Addendum #1
SCUSD Bid #1095
Floor Replacement Project Hughes and Montague Elementary Schools
3/8/2021

CHANGES AND/OR CLARIFICATIONS OF THE BID SPECIFICATIONS AS FOLLOWS:

PROJECT
HUGHES AND MONTAGUE ELEMENTARY SCHOOLS FLOORING REPLACEMENT PROJECT

ITEM NO. 1.5 Revision to Demo Notes

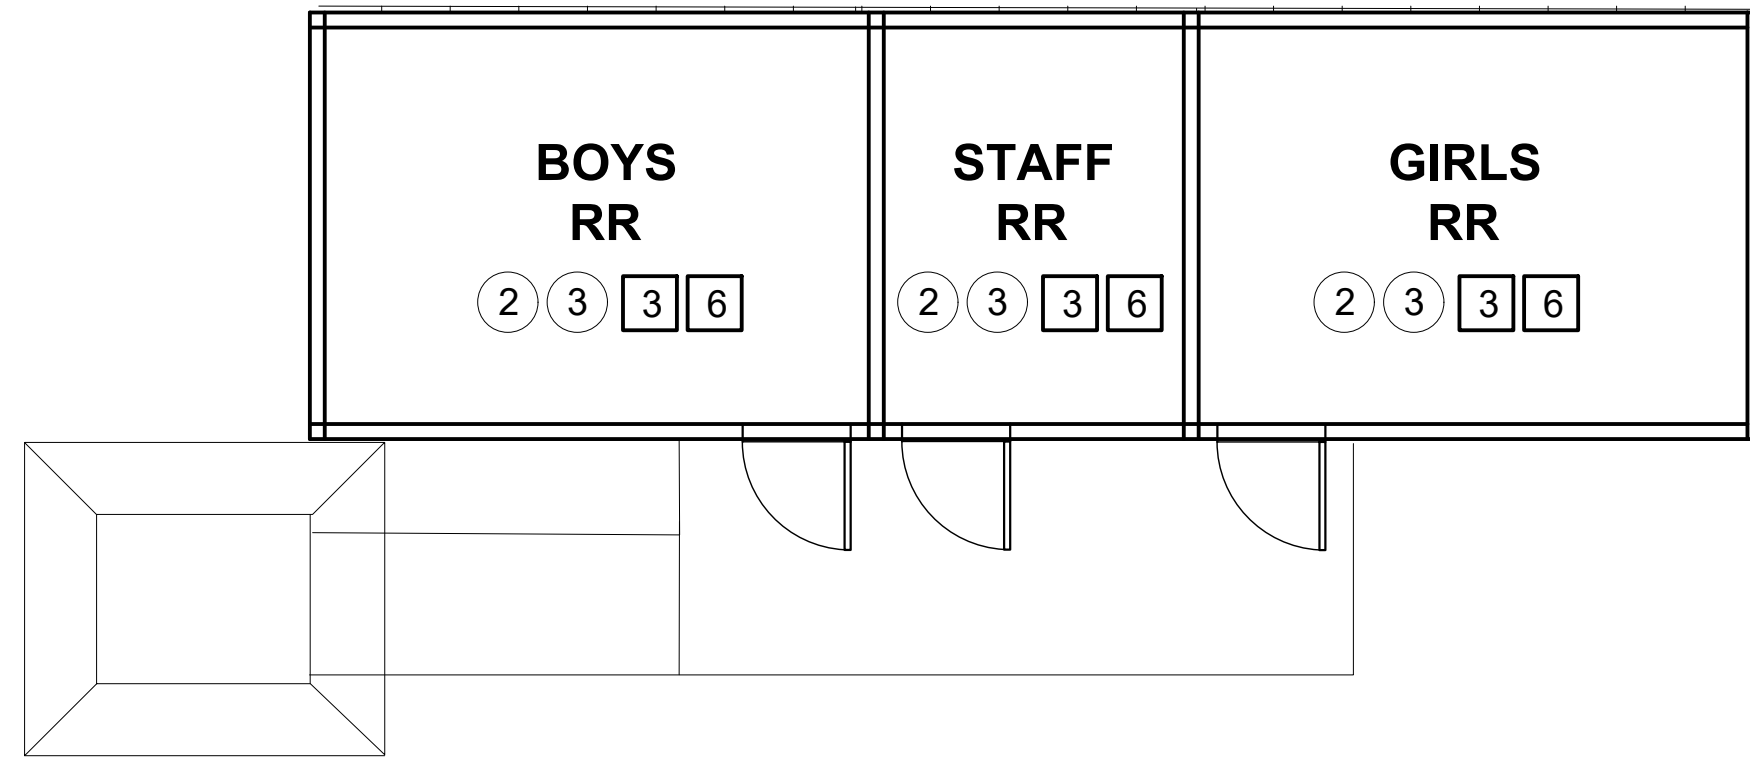
Demo Notes 1 and 2 have been updated.

A1.5

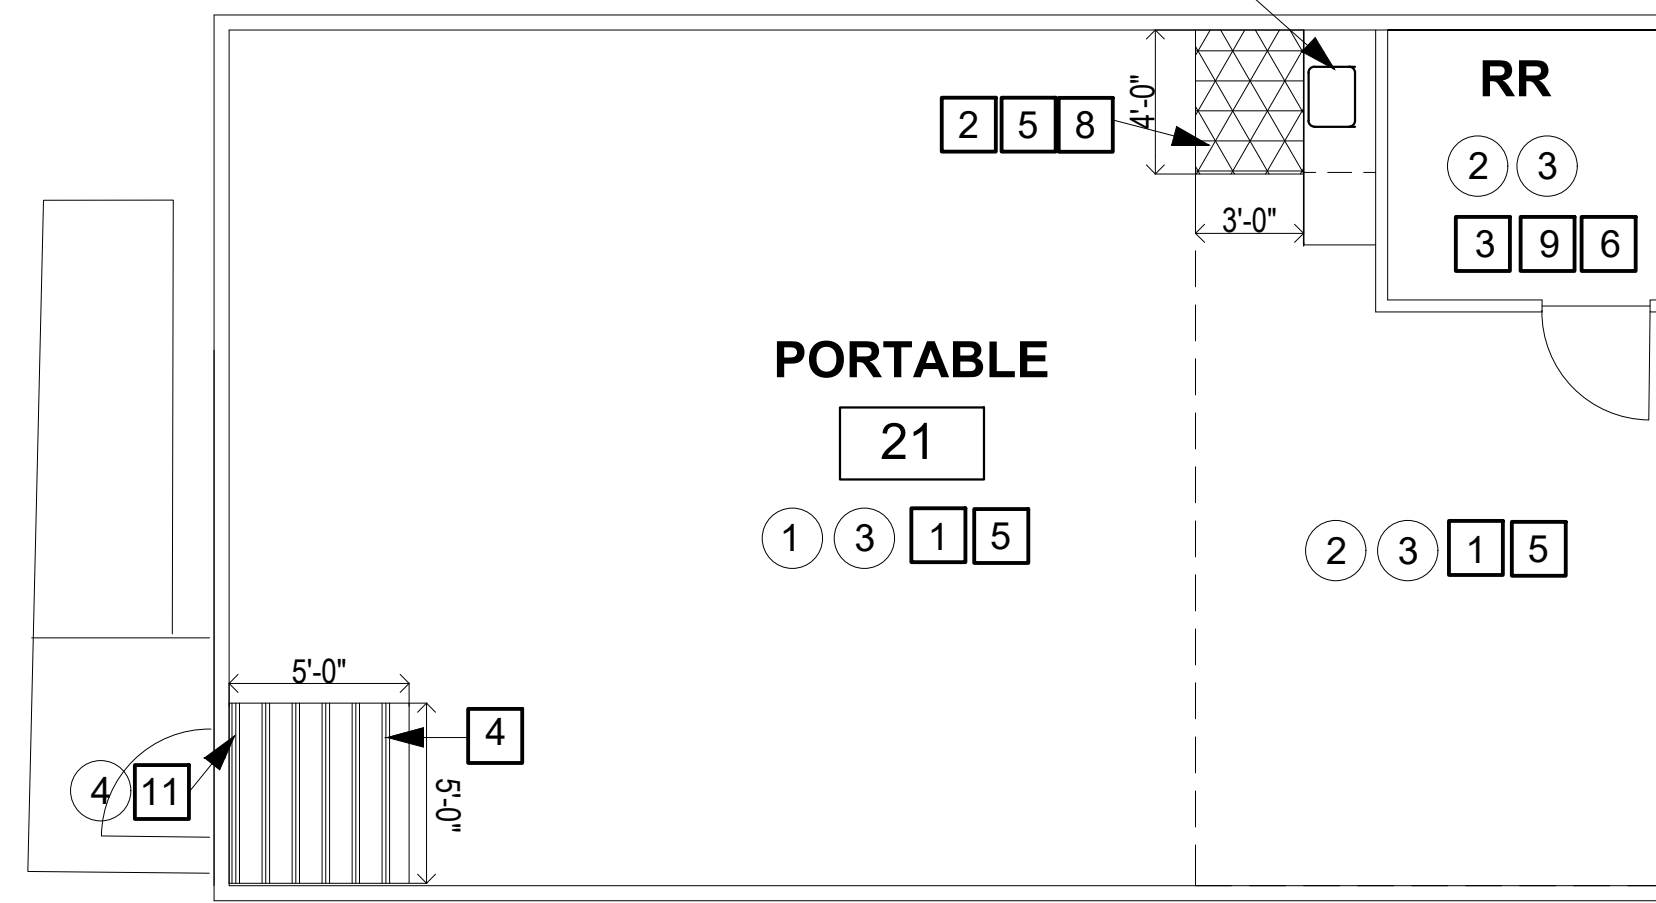
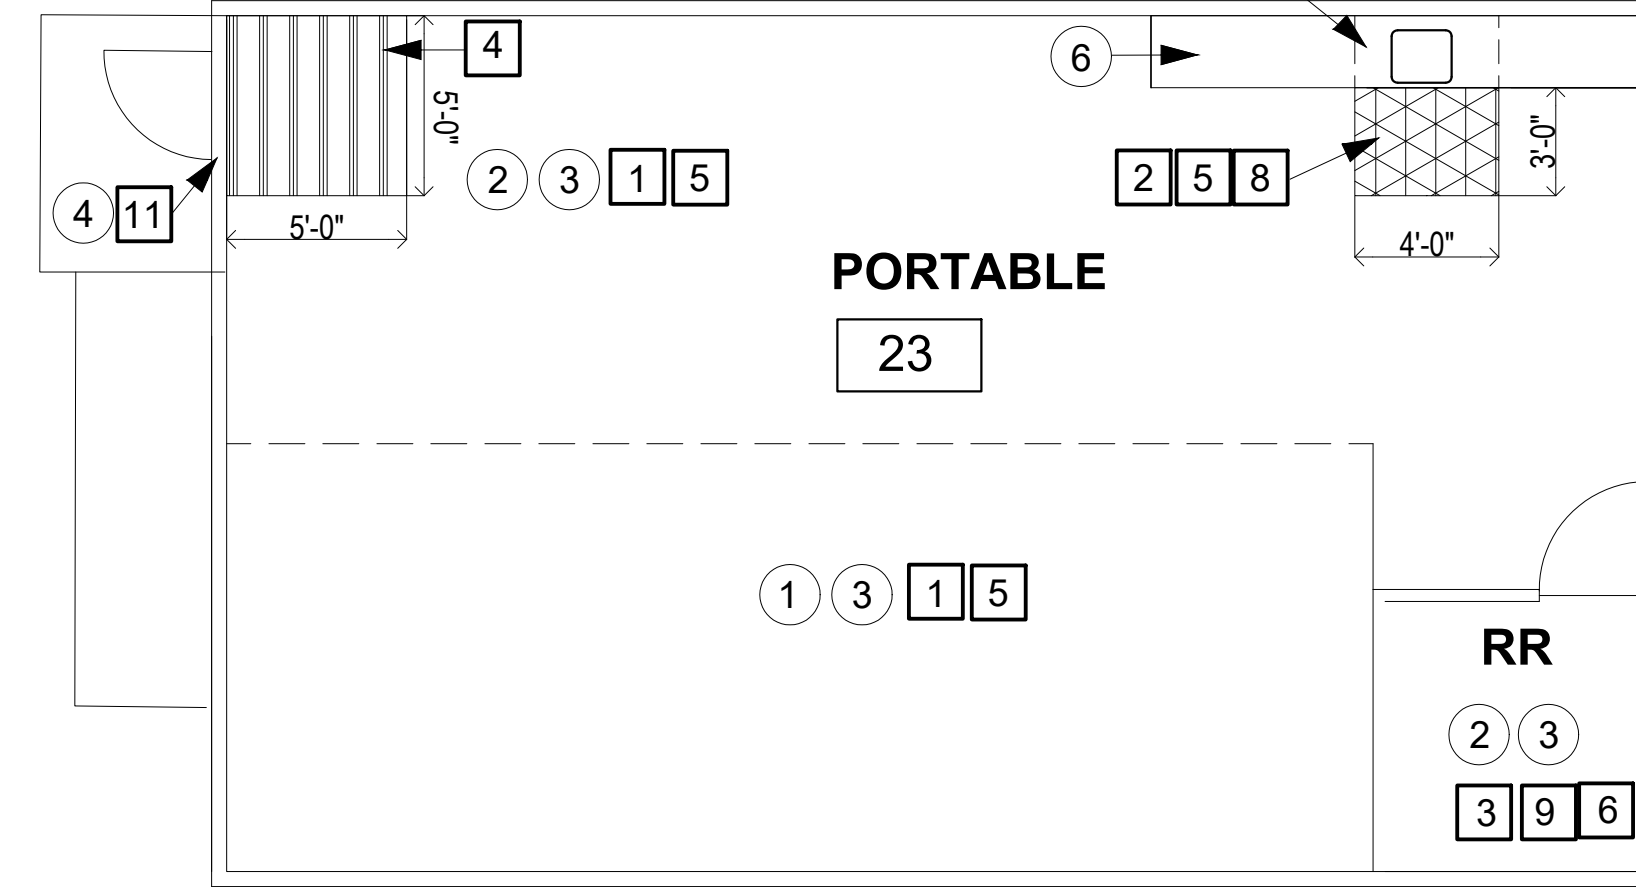
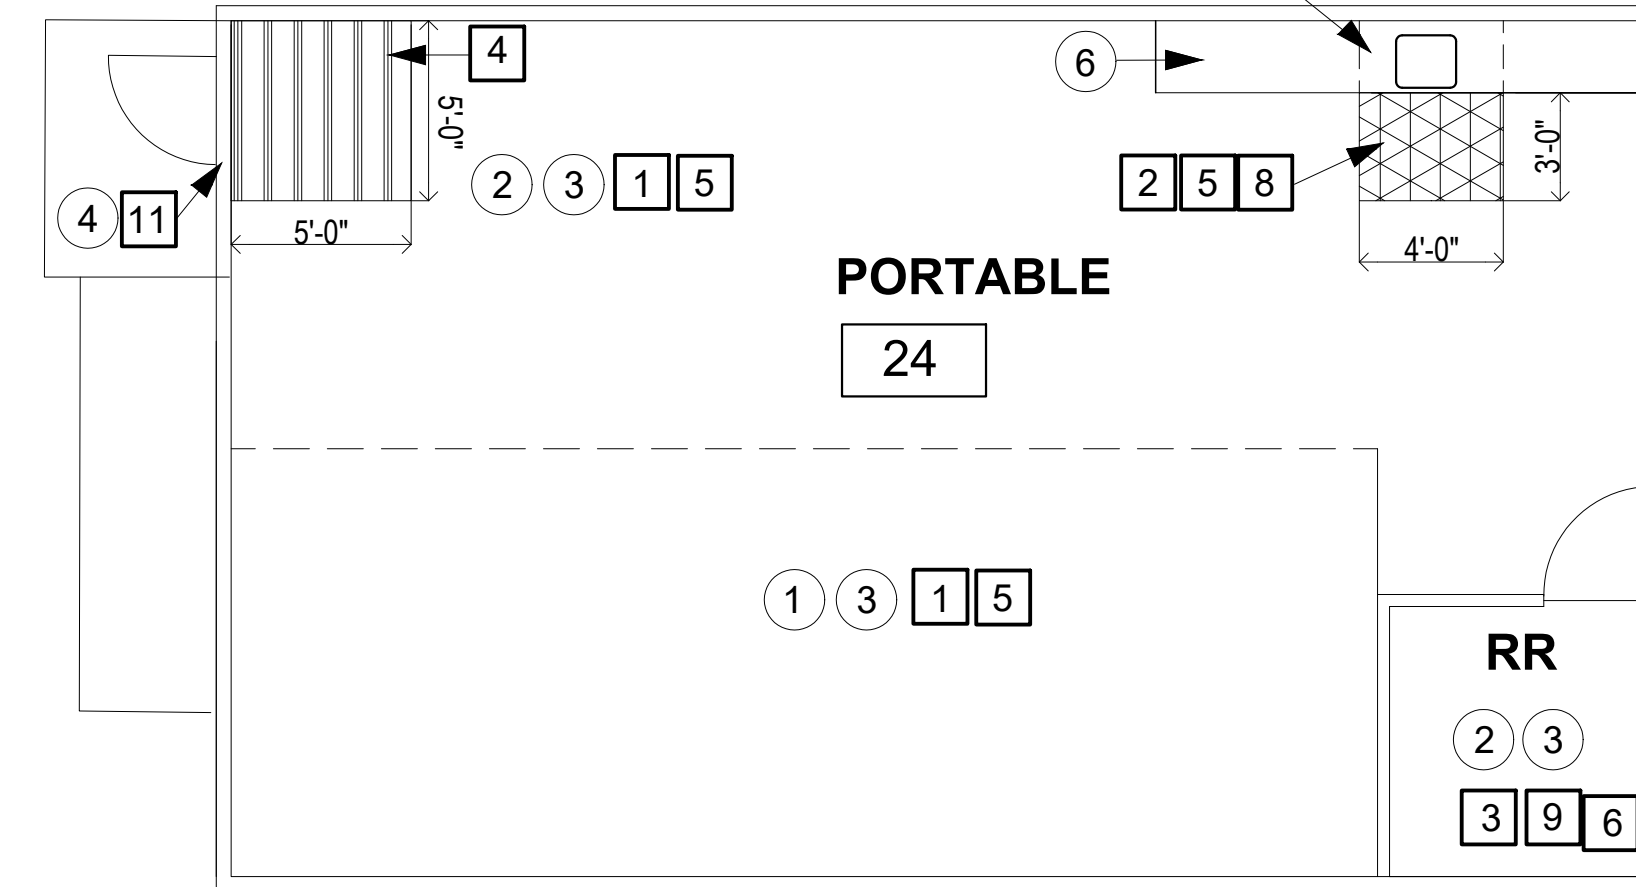
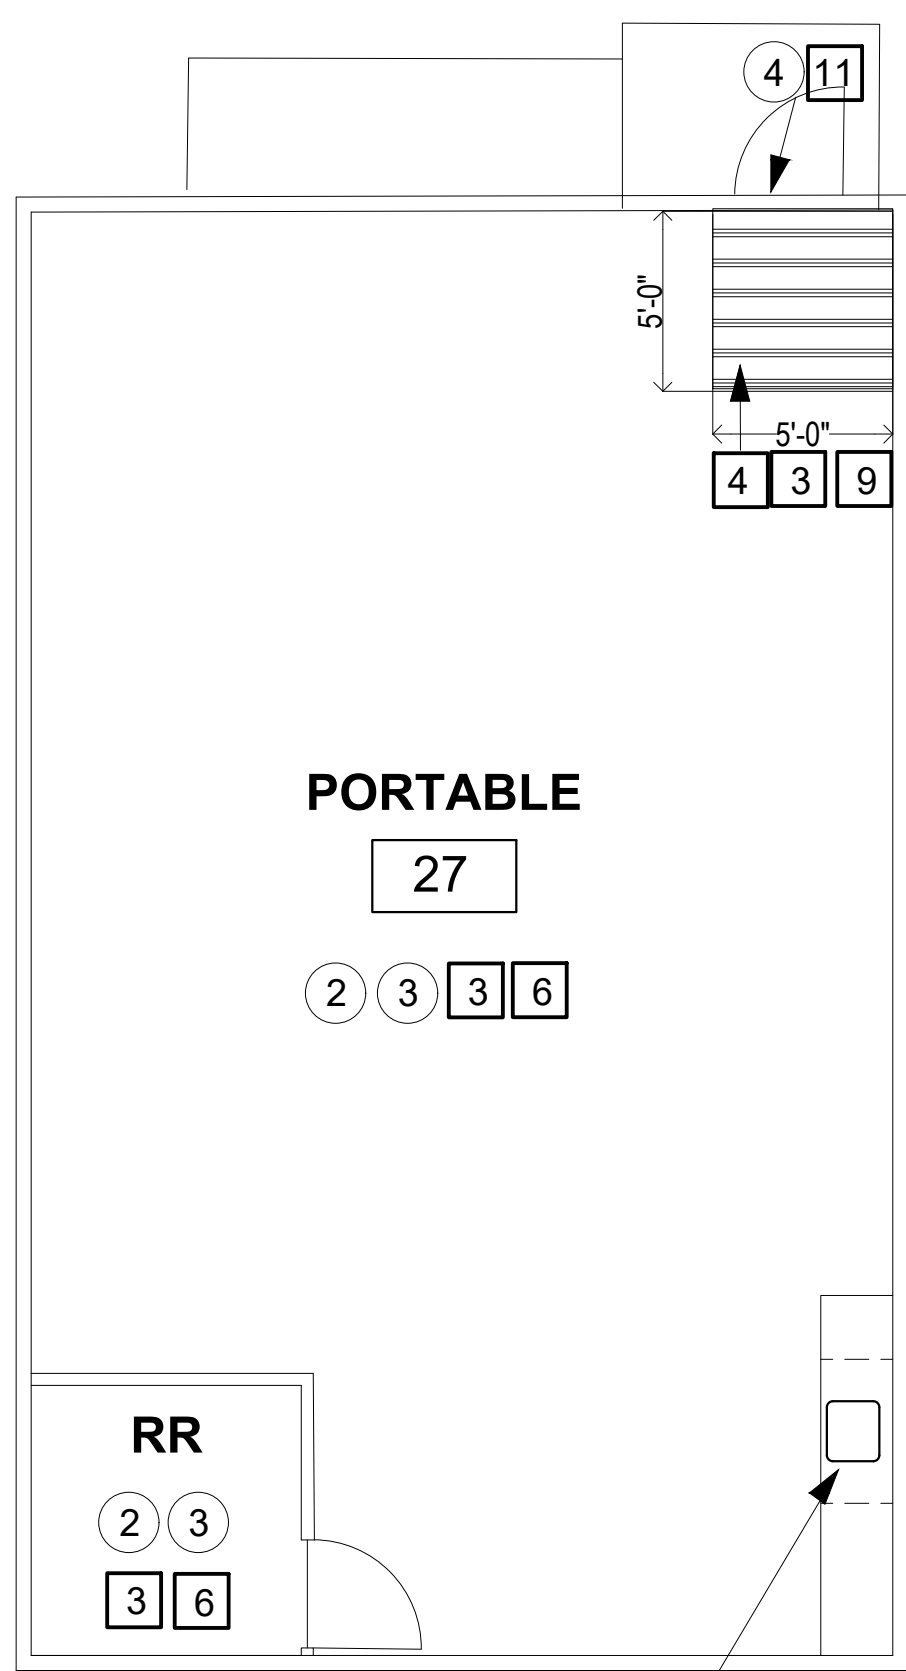
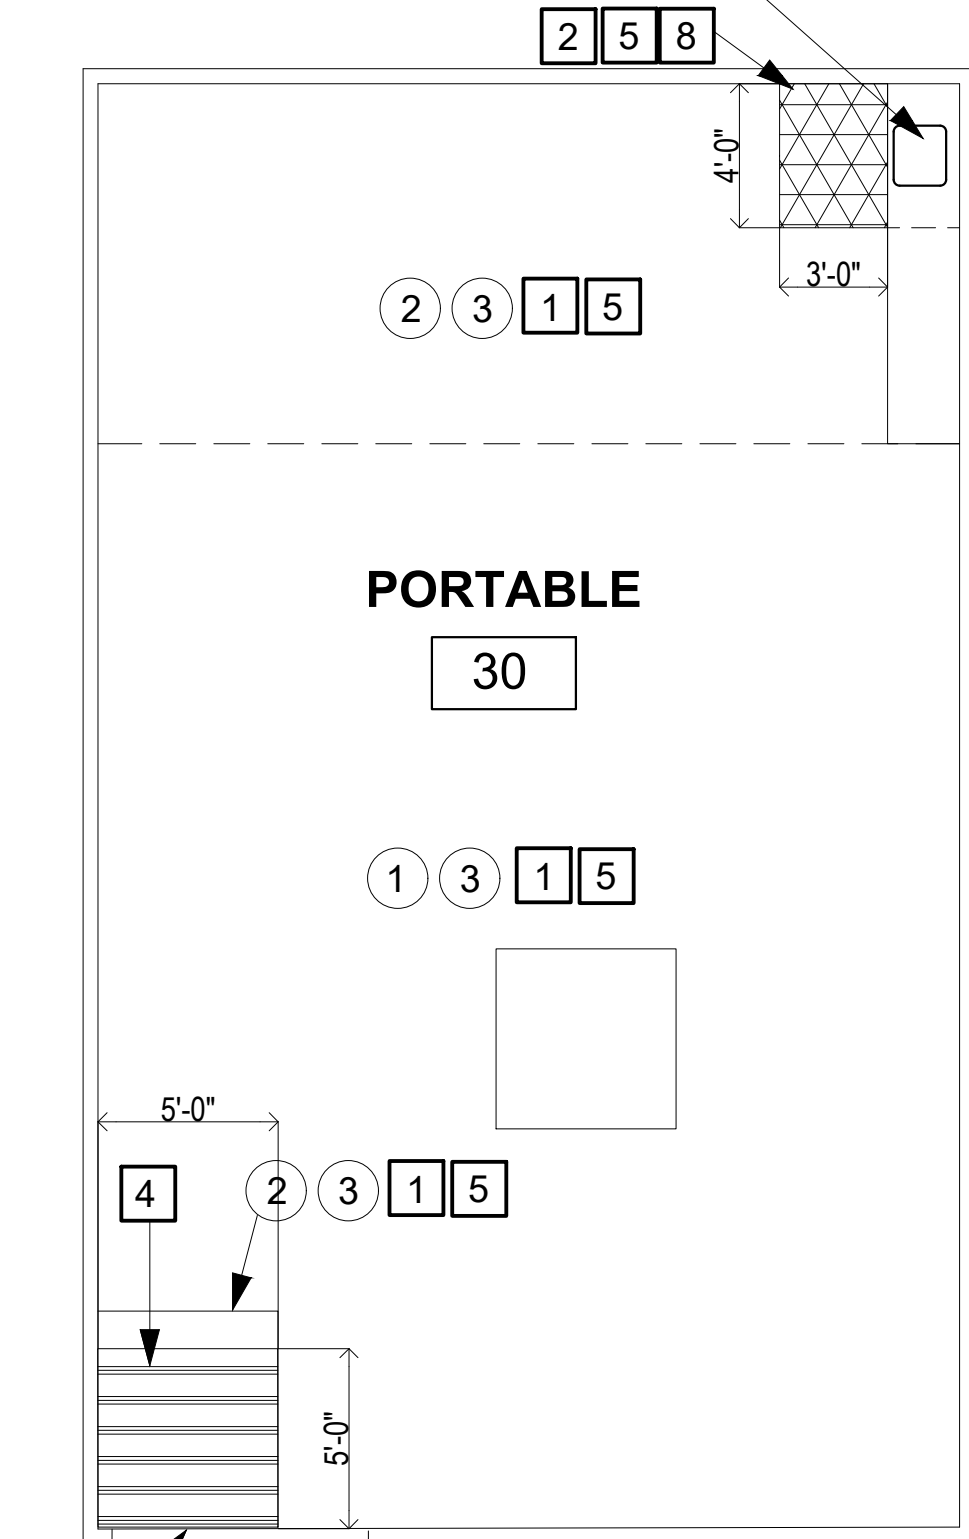
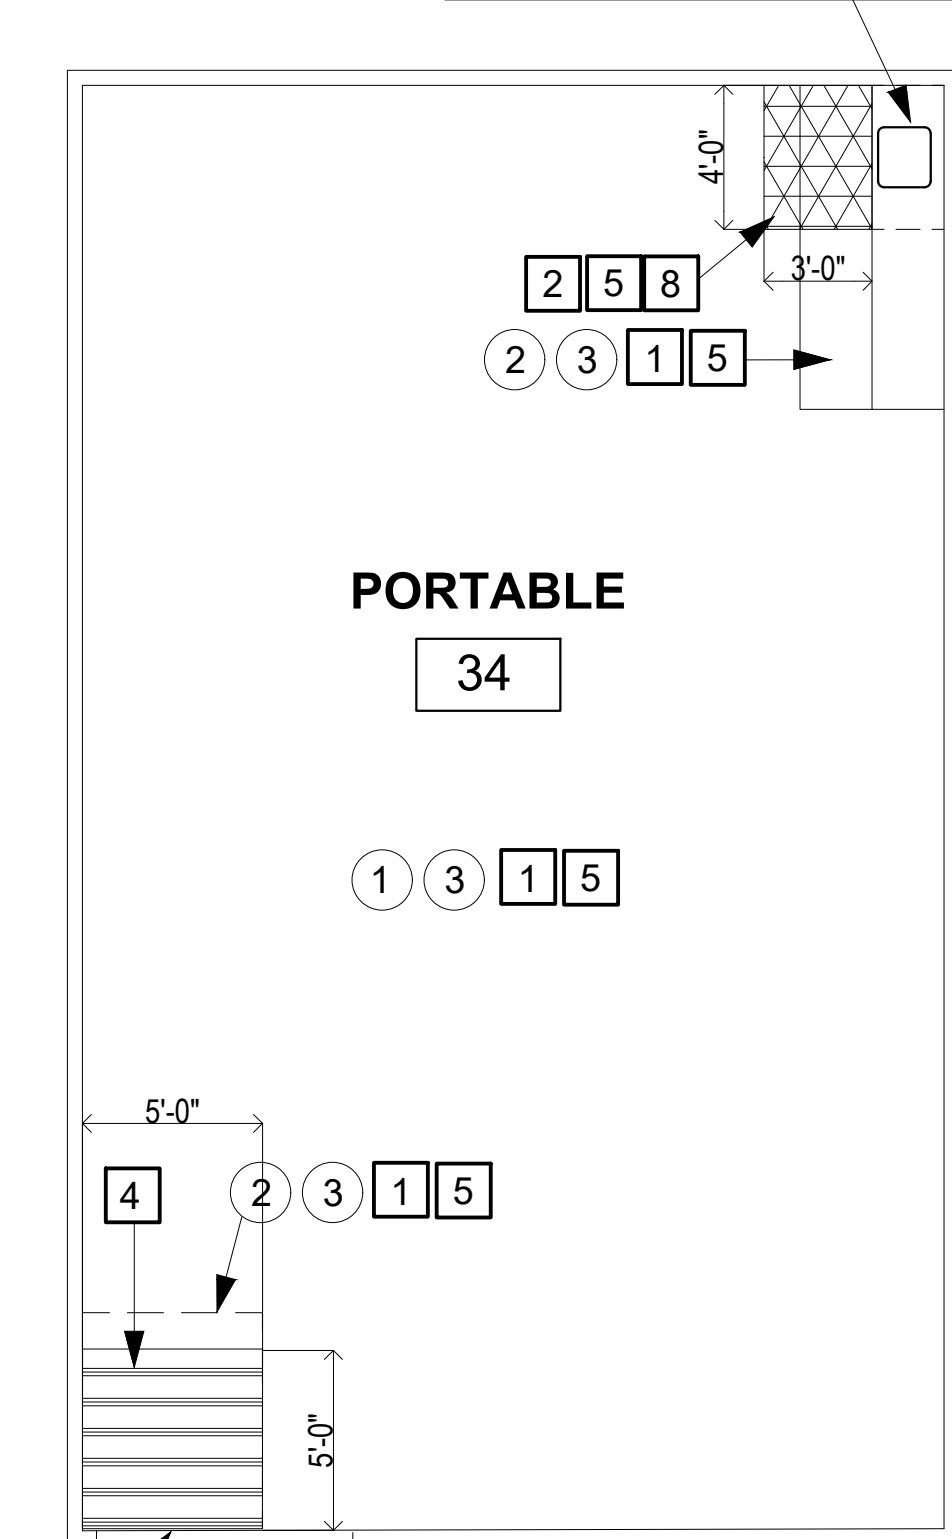
Revisions have been made to the layouts and scope for Portables 21, 23, 24, 27, 30, 34, 35, and 37 at Hughes, and Portable 25 at Montague. Sheets A1.5 and A2.5 have been updated.
